## TECHNICAL EVALUATION REPORT

**RADIOLOGICAL EFFLUENT TECHNICAL  
SPECIFICATION IMPLEMENTATION (A-2)**

BIG ROCK POINT NUCLEAR POWER PLANT

NRC DOCKET NO. 50-155

Figure 1. Liquid Radwaste Treatment Systems, Effluent Paths, and Controls for Big Rock Point Nuclear Power Plant (taken from Licensee-proposed ODCM) [29]

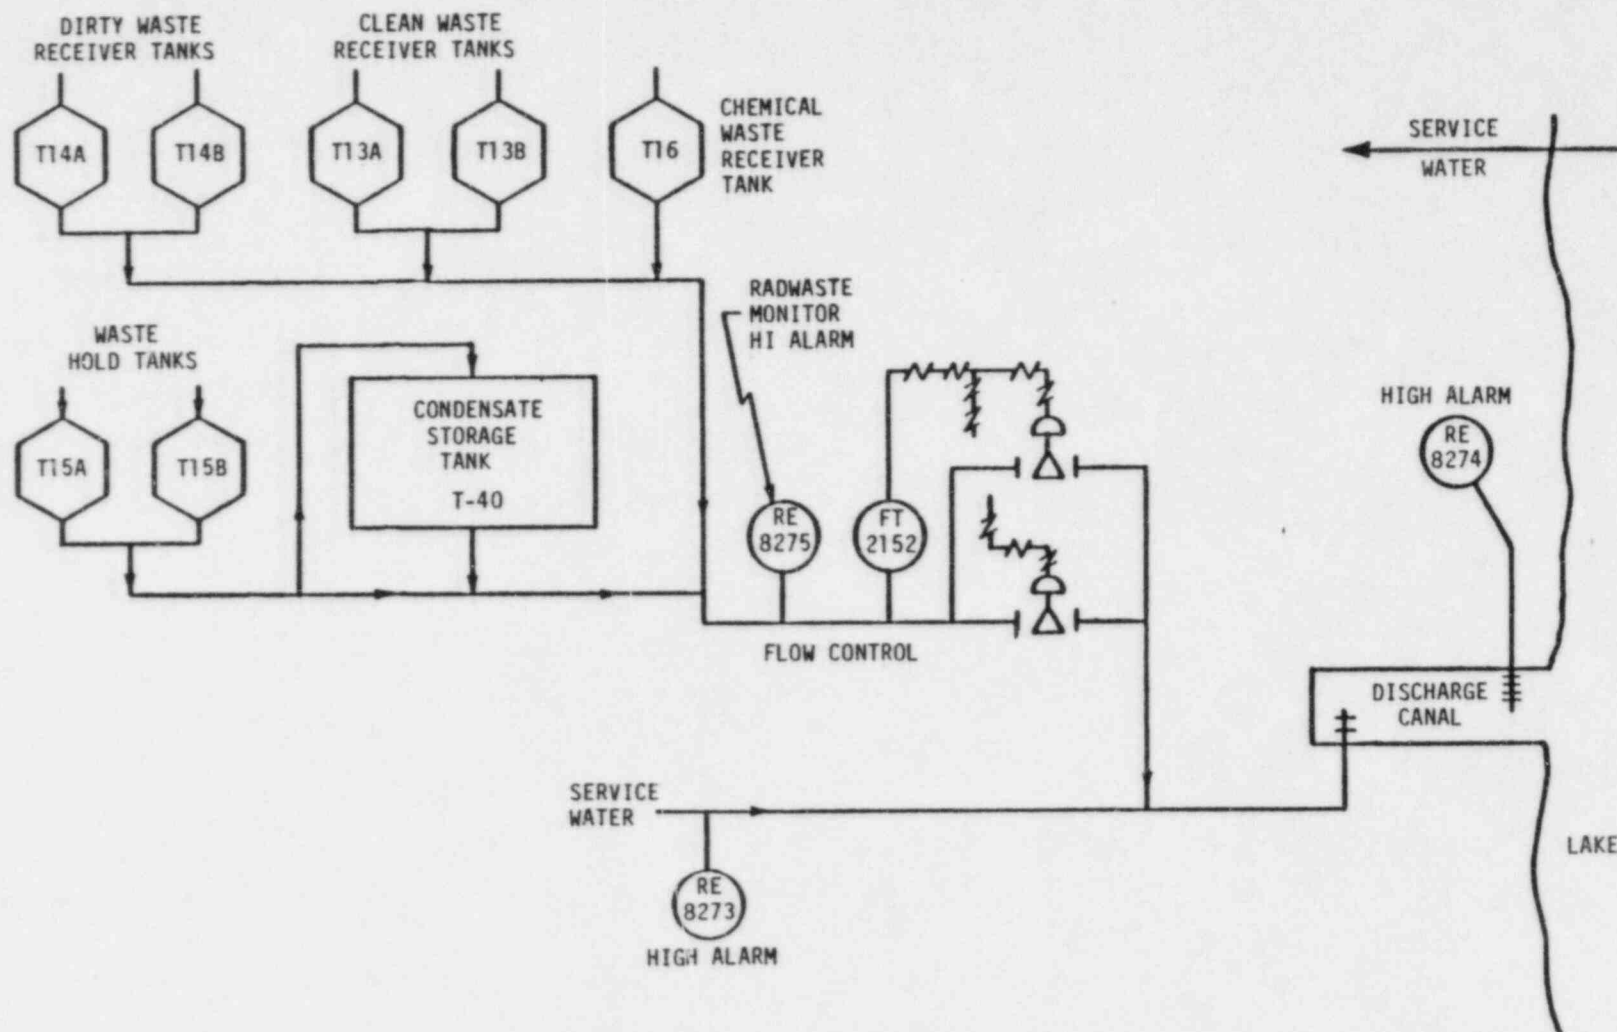
A radiation monitor (RE-8275) has been installed for the liquid radwaste effluent line (Figure 1) which combines effluent streams from the releases of clean wastes, chemical wastes, dirty wastes, and miscellaneous wastes. This monitor at the radwaste effluent line is equipped with an alarm function. The Licensee has also provided a radiation monitor (RE-8274) for circulation water at the discharge canal. A radiation monitor (RE-8273) with high alarm has been installed for the service water effluent line and is considered a process monitor.

These existing monitoring capabilities have provided adequate assurance that the provisions of NUREG-0473 for the radioactive liquid effluent monitoring instrumentation are met.

Figure 2. Gaseous Radwaste Treatment Systems, Effluent Paths, and Controls for Big Rock Point Nuclear Power Plant  
(taken from Licensee-proposed ODCM) [29]

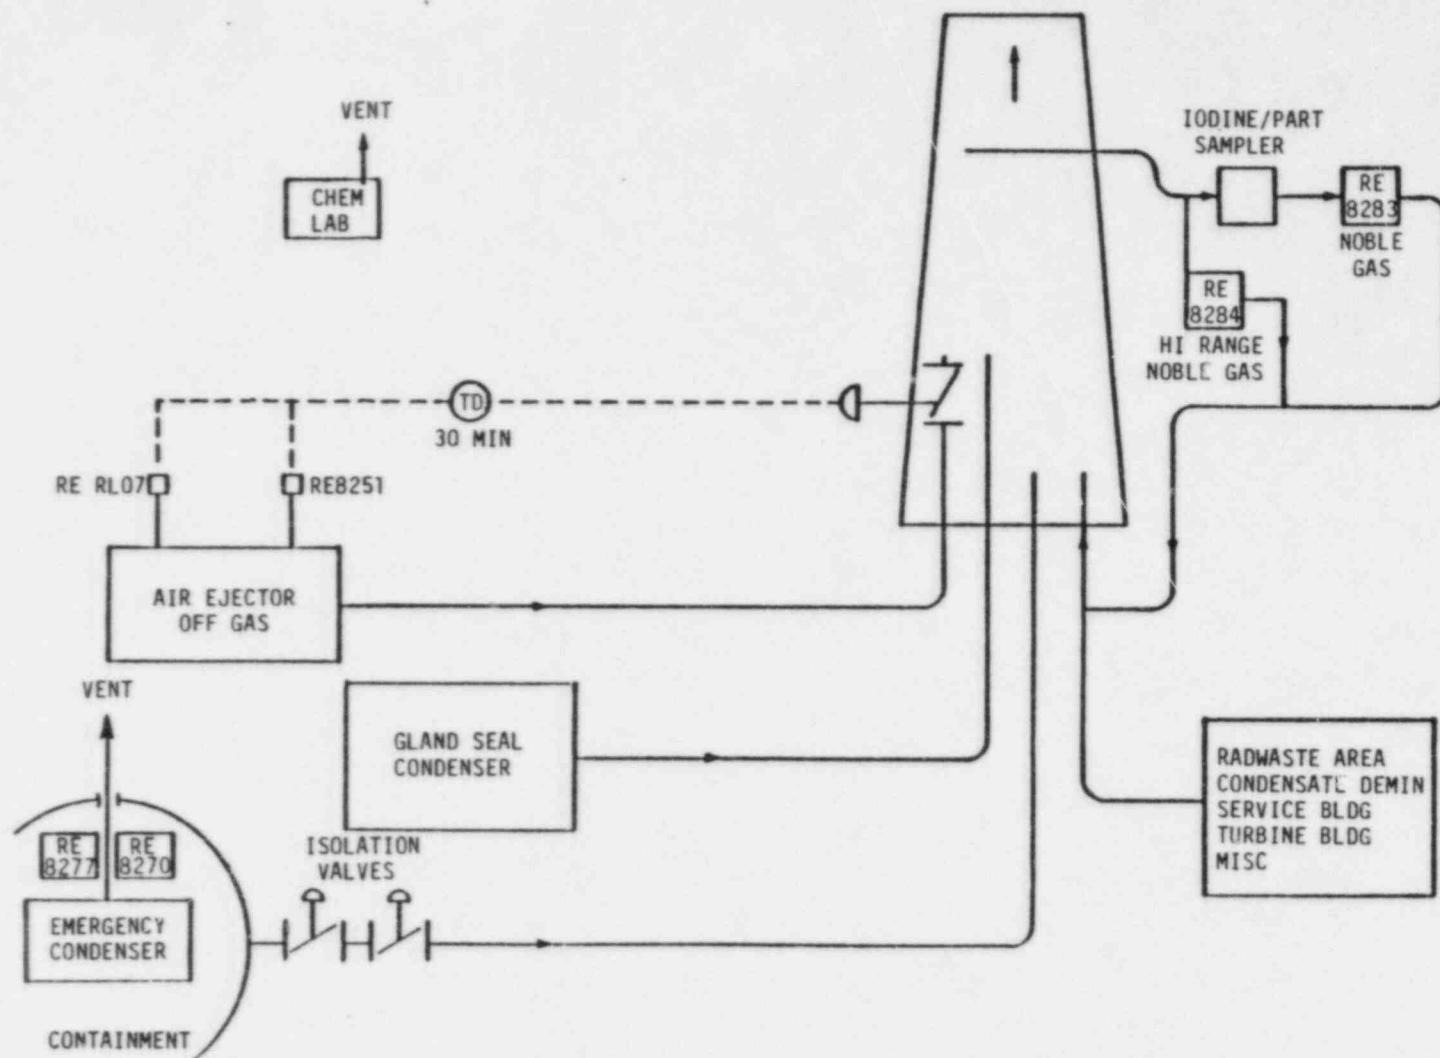
The Licensee has provided noble gas monitors (RE-8251 and RE-8283) for the air ejector offgas system and stack gas effluent system, respectively. The monitor at the air ejector has alarm and automatic control functions. For the stack gas effluent system, an iodine/particulate sampler is also provided.

The existing monitoring capabilities provided by the Licensee have met the intent of NUREG-0473 for radioactive gaseous effluent monitor instrumentation.
